# Discussion Slides - Annex 120G gdc

120G	MI SI calibration + gdc	72, 131, dudek_01
120G	EO RR bbmax/gdc	100, 98(R+), 99(R+), 115, 72

Table 120G-11—Eye opening reference receiver parameter values

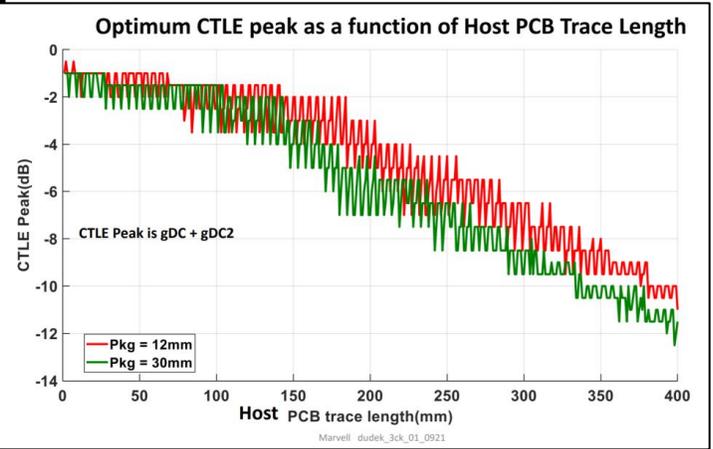
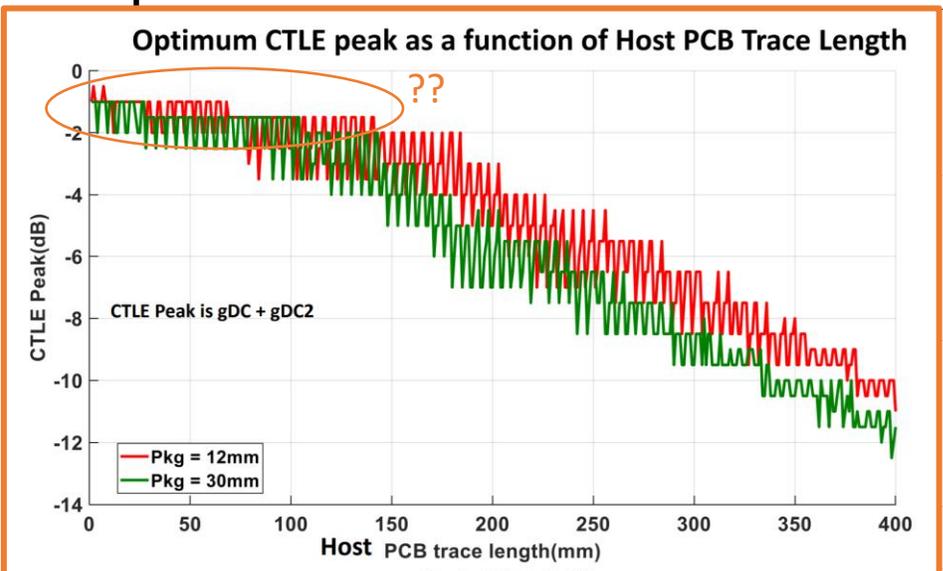
CI 120G SC 120G.3.4.3.2 P 274 L 17 # 72

Dudek, Mike Marvell  
Comment Type TR Comment Status D MI SI calibration

The optimum value of CTLE peaking ( $g_{dc} + g_{dc2}$ ) when calibrating the high loss stressed module receiver test is only 10.5dB. See Dudek\_3ck\_01\_0921. Requiring at least 13dB is degrading the signal making it difficult to generate the signal (see e.g. Snapshot of Receiver Module Input Tests (no convergence on high-loss TP1a channel) and private discussions). Note also that the maximum allowed peaking for testing the host output should not be significantly different from this value. A presentation will be made.

**Suggested Remedy**  
Change -13dB to -10.5dB. Also in Table 120G-11 change the  $g_{dc}$  values for TP1a range for  $-1 < GDC2 < 0$  to -2 to -11, the range for  $-2 < GDC2 < -1$  to -4 to -10, and the range for  $-3 < GDC2 < -2$  to -4 to -9

Comment	Response
72	Accept, analysis/presentation is justification
115	Reject, limited justification
99	Reject, limited justification
98	AIP; accept editorial change of the TP1a style makes it easier to read. With 99 rejected, no justification requiring separate entries for short/long.

g) Eye height and VEC are measured at TP1a as described in 120G.5.2 with the exception for the high-loss case that the reference receiver CTLE setting that minimizes VEC has  $g_{DC} + g_{DC2}$  less than or equal to -10.5 dB.
